Response to Comments by Anonymous Referee #2

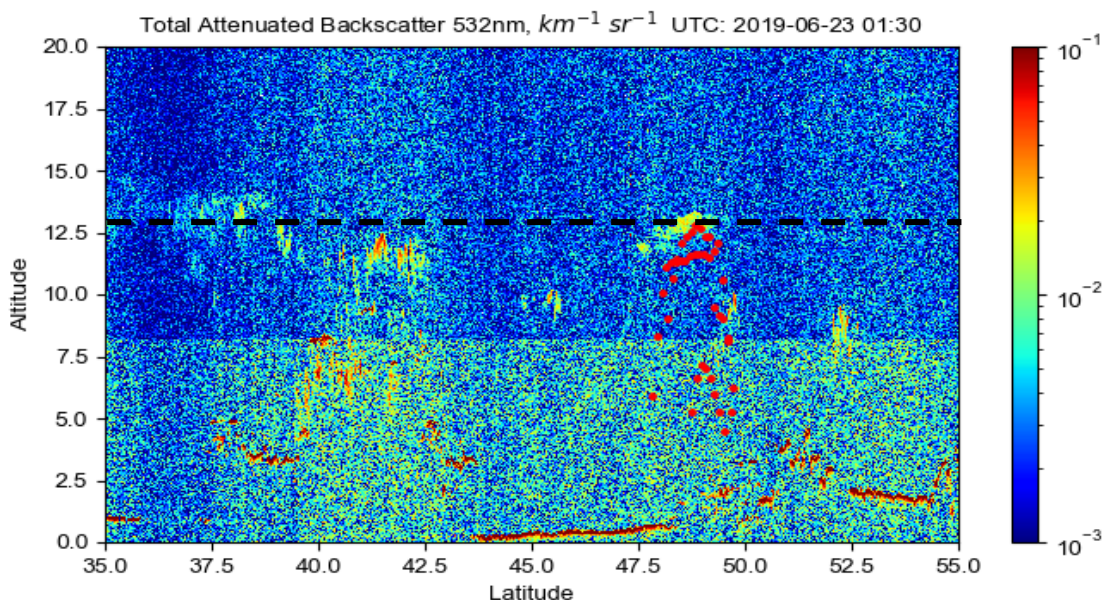
6) Section 4: What are the expected uncertainties of the validation data products used - the text talks about reasonable agreement, but there are differences of several km's in some cases, so it would be useful to know if that can be explained by uncertainties in the other datasets as well? In particular, for Kasatochi, the quoted values for prior OMI retrievals are a few km's lower – has the reason for this been looked at in more detail?

For TROPOMI retrieval (Hedelt et al., 2019) there is a stated retrieval uncertainty of < 2km for SO₂ column of greater than 20 DU. However, this is only for the retrieval using the synthetic data. Using real data also adds a certain degree of error. The IASI retrieval also contains an uncertainty of 2 km. In some cases there is more than 2 km difference between different datasets. In addition to uncertainties within validation datasets there are also differences between retrieval technique which could also add to the differences.

The previous OMI SO₂ height retrieval pertaining to Kasatochi is from Yang et al, 2010. The height values for Kasatochi were found to be around 9-11 km with uncertainty of up to 2 km as well. We believe this is within reasonable range of our retrieval, especially taking the difference

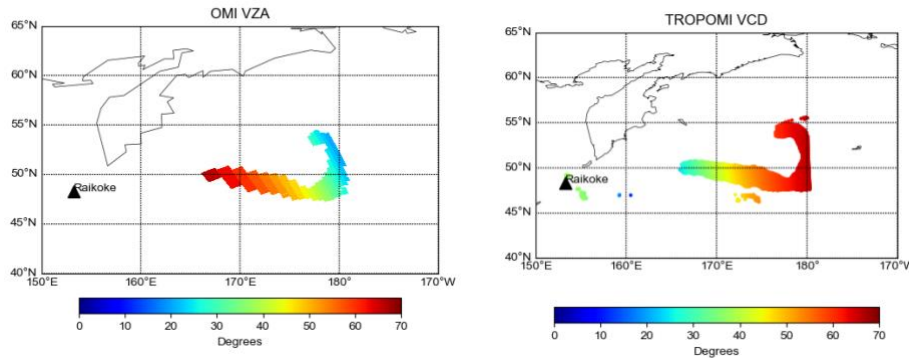
- 7) Figures 4, 5, 7: These would be clearer if all the instruments were plotted on the same colour scale and lat/lon range. Also, if possible, replot the Caliop data to focus on the relevant region. Similarly for Figure 8, it would be clearer if all the instruments were plotted on the same axes.**

For the CALIPSO lidar data, we agree that it would be helpful to focus in on the region with the volcanic plume. The figures have been replotted for the revised manuscript. As an example here is one for Raikoke (June 23rd, 2019) which would correspond to Figure 9a.
